Historic Review Staff Report and Recommendation April 16, 2019

FILE NO.: GLUA 19-05/HR 19-01 - Alteration of a Designated Structure

REQUEST: Addition of a projecting sign and wall signs on the front and side facades of a

designated historic structure in the McLoughlin Conservation District (I.O.O.F.

Figure 4. Proposed Sign Mock-up: 7th Street Façade

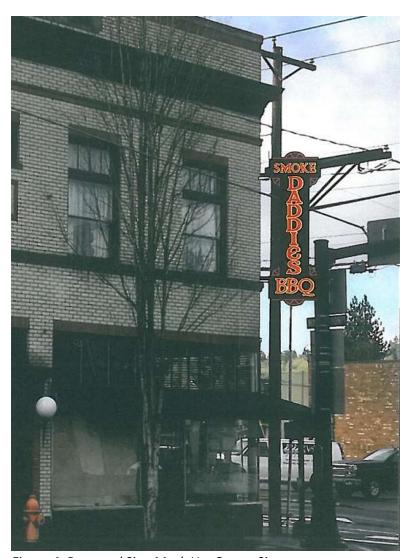
Staff has concerns about the proposed marquee style wall sign; these concerns are also reflected in comments from the State Historic Preservation Office. The marquee style, while of the appropriate era, is very specific to theaters. This building does not have any historic use as a theater, and the sign style may create a false sense of history, which is antithetical to the Secretary of Interior's Standards previously cited.

Staff recommends that the bulbs around the perimeter of the sign, which give the sign a theater aesthetic, be removed or replaced with a different feature.

The placement of the wall sign along 7th Street sign is very close to red brick detailing, including the belt cornice that separates the two floors of the building. The belt cornice is an architectural feature that should not be obscured, per the previously cited guidelines. Staff recommends that any signs on the 7th Street facade should be placed to leave at least three inches between the edge of the sign and the red brick detailing.

The placement of the wall sign along 7th Street sign does not leave space between the sign and the red brick detailing, including the belt cornice that separates the two floors of the building. The belt cornice is an architectural feature that should not be obscured, per the Secretary of Interior's guidelines, and furthermore, it should be visually separated from the signs such that the edges of the architectural details

The marquee style of the 7th Street wall sign, however, while of the appropriate era (1920s), is very specific to theaters. This building does not have any historic use as a theater. A comment from the State Historic Preservation Office opines that the marquee style does create a false sense of history on this particular building, insinuating that the building has historic use as a theater. Staff recommends that the bulbs around the perimeter of the sign, which give the sign a theater aesthetic, be removed or replaced with a different feature. The bulbs may be replaced with red striping or other elements that do not suggest a theater marquee and that are compatible with the building and the other proposed signs.

The placement of the wall sign along 7th Street sign does not leave space between the sign and the red brick detailing, including the belt cornice that separates the two floors of the building. The belt cornice is an architectural feature that should not be obscured, per the Secretary of Interior's guidelines, and furthermore, it should be visually separated from the signs such that the edges of the architectural details are apparent. Staff recommends that any signs on the 7th Street facade should be placed to leave at least three inches, or the height of one brick, between the edge of the sign and the red brick detailing.

- 1. If the signs are removed from the building in the future, the applicant shall ensure that the walls are repaired to the previous condition with no holes or visible evidence of signage installation. (P)
- 2. The wall sign on the 7th Street facade shall be sized to provide at least three inches, or the height of one brick, between the edges of the sign and the red brick detailing on the building. (P)
- 3. The applicant shall remove the bulbs around the perimeter of the wall sign on the 7th Street façade. The bulbs may be replaced with red striping or other elements that do not suggest a theater marquee and that are compatible with the building and the other proposed signs. (P)

Figure 4. Proposed Sign Mock-up: Washington Street Facade

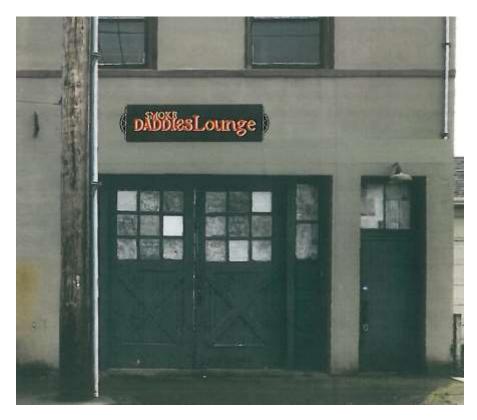
Staff finds that the wall signs proposed on the Washington Street façade of the building, can be found to be compatible. The placement of the signs on the blank wall areas of the building does not compete with or conceal any historic features. The signs are made of aluminum with lighting sources concealed. The edges of the signs do not have molding, but the modern style presents a finished appearance.

Staff Finding: Complies with Conditions. The proposed wall signs on the Washington Street façade will not create a false sense of historical development. The aluminum signs with backlit lettering will be clearly modern.

Staff finds that the wall signs proposed on the Washington Street façade of the building, can be found to be compatible. The proposed wall signs on the Washington Street façade of the building fill space on a flat section of the façade between architectural elements. The placement of the signs on the blank wall areas of the building does not compete with or conceal any historic features. The aluminum signs with backlit lettering will be clearly modern.
